COMMENT RESPONSE TO DOCUMENT REVIEW: TECHNICAL MEMORANDUM; REVISED
FIELD SAMPLING PLAN AND DATA QUALITY OBJECTIVES, THE WEST SPRAY FIELD
(IHSS 168) OPERABLE UNIT 11, ROCKY FLATS PLANT

FIGURE 3-2

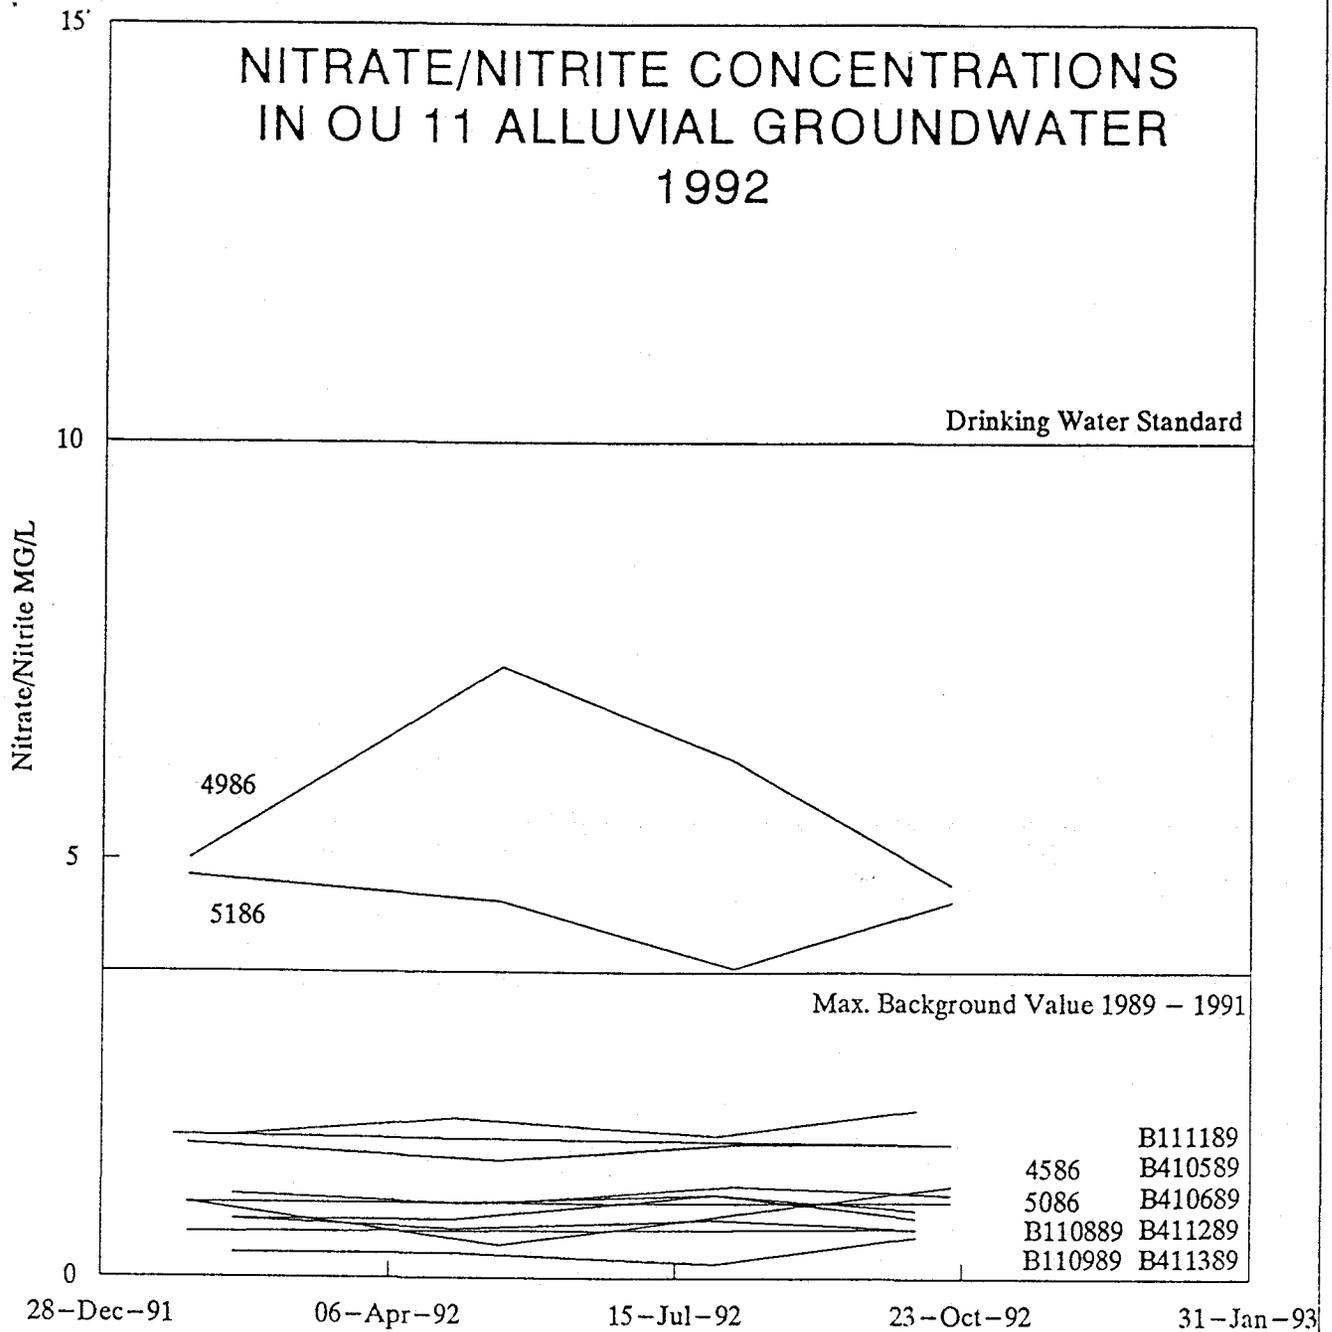
13. Section 3.1.3, p. 3-6, first paragraph: Please provide the supporting information that wells screened in both the unsaturated and saturated zones have elevated nitrate levels. A figure showing the boring log information with a corresponding chart showing nitrate levels over time would be very useful to support the discussion.

To support this conclusion, a figure showing nitrate levels over time for all monitoring wells in the OU 11 network has been included as figure 3-2 and appropriate reference to that figure has been made within the text.
